Project Description: Stateside Subdivision

Project/File: **Stateside Subdivision / GCPP25-0002 / SUBFY2025-0002**

This is a design review and preliminary/final plat application to allow for the development of 134 townhome lots on 10.27-acres. This site is located within the Residences at River Club Specific Area Plan District in Garden City.

Lead Agency: Garden City

C. Site Plan

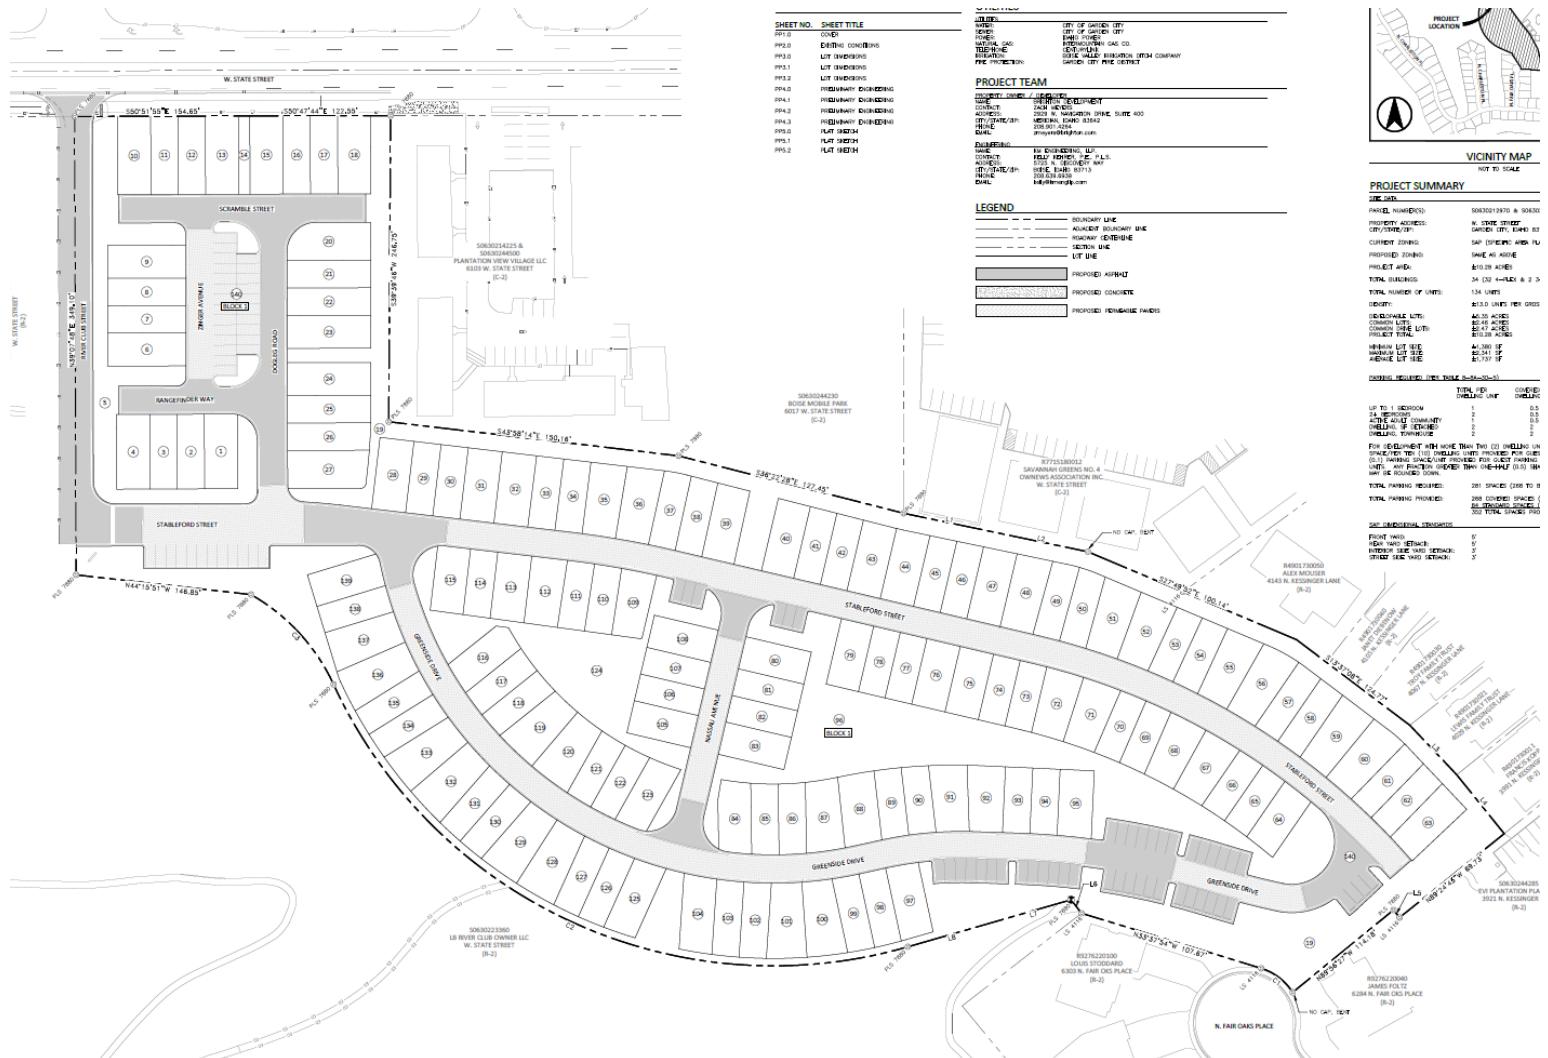
4. If required by the Boise Fire Department, construct a 20-foot wide emergency-access only driveway from the site onto Fair Oaks Place located 482-feet north of Plantation Lane.

Install bollards or gates to restrict the driveways to emergency-access only as determined by the Boise Fire Department. The bollards or gates shall be located outside of the dedicated right-of-way.

c. Staff Comments/Recommendations: The applicant's proposal exceeds District policy with exception of the width of the planter strip and should be approved, as proposed. The applicant should be required to coordinate with ACHD to ensure that the proposed pathway is constructed behind the bioretention basins and planter strip being constructed through the ACHD State Street and Pierce Park intersection project currently under construction.

c. Staff Comments/Recommendations: As a part of GC22-0022, staff recommended that the driveway approach within right-of-way be constructed by ACHD as part of the State Street and Pierce Park Lane intersection project. Staff recommended the applicant be responsible for all costs associated with the design and construction of their driveway approach within ACHD's right-of-way including all labor and materials costs, as well as any utility relocations.

If required by the Boise Fire Department, the applicant's proposal for the 20-foot wide emergency-access only driveway should be approved, as proposed. The applicant should be required to install bollards or gates to restrict the driveways to emergency-access only as determined by the Boise Fire Department. The bollards or gates shall be located outside of the dedicate right-of-way. If the emergency-access only driveway is not approved by the Boise Fire Department, the applicant shall be prohibited from taking vehicular access from Fair Oaks Place.

1. Construct 10-foot wide detached sidewalk behind the planter strip and bioretention basins being constructed by ACHD as a part of the State Street and Pierce Park Lane intersection project currently under construction abutting the site on State Street and tie the 10-foot wide detached sidewalk into improvements on either side of the site.

2. Dedicate right-of-way to extend to 2-feet behind back of sidewalk or provide a permanent right-of-way easement from the right-of-way line to 2-feet behind back of sidewalk on State Street.

3. If Garden City approves the private road, the applicant shall be required to pave the private roadway at least 30-feet into the site beyond the edge of pavement of all public streets. If private roads are not approved by Garden City, the applicant will be required to revise and resubmit the preliminary plat to provide public standard local streets in these locations.
